JOINT OWNERS' GROUP

Motor-Operated Valves

Subject: JOG MOV PV Program Revised Data for Valve B22.4

Enclosure: (1) Revised pages to JOG MOV PV Summary Report (MPR-2524-A),
6 pages total

Figure 4-18. Bearing Friction Coefficient for Butterfly Valves with Tefzel and Teflon-Lined Bearings on Stainless Steel Backings

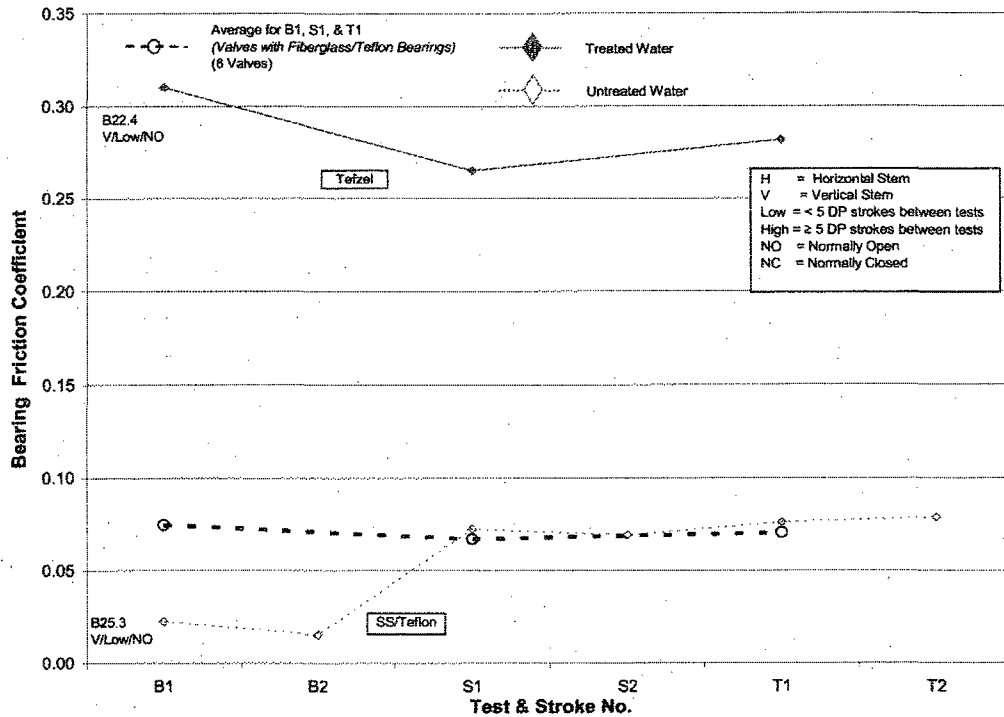
The Joint Owners Group (JOG) previously submitted the Motor-Operated Valve (MOV) Periodic Verification (PV) Program Summary for NRC Review and acceptance. Recently it was found that the input design data for Valve B22.4 used in MPR-24-524-A was found to be incorrect, which affects the results in MPR-2524-A. This information has been distributed to the Owners Groups participants for evaluation. Attached are the affected pages of MPR-2524-A, which have been revised to show the corrected data for B22.4. Based on a survey done of the program participants, the impact for all BWROG and PWROG plants is considered minimal, with only one plant reporting use of this type valve. A copy of this revision is provided to the NRC for your information. This Letter is also being transmitted to all Owners Group participants.

7. For butterfly valves with bearings made of Teflon in a fiberglass carrier, Teflon on a stainless steel substrate, or Tefzel, the bearing coefficient is stable in treated water. In untreated water, there are slight variations (increases and decreases) in bearing friction coefficient. A few valves with low initial bearing friction coefficients increased during testing to values more typical of the average. A bearing friction coefficient of 0.13 is the bounding value of all the COF data from butterfly valves with Teflon/fiberglass and Teflon/stainless steel bearings in both treated and untreated water. This bounding value (0.13) is also the value that bounds 95% of the COF data. For Tefzel, a Teflon derivative expected to have higher friction, the maximum observed COF was 0.31.
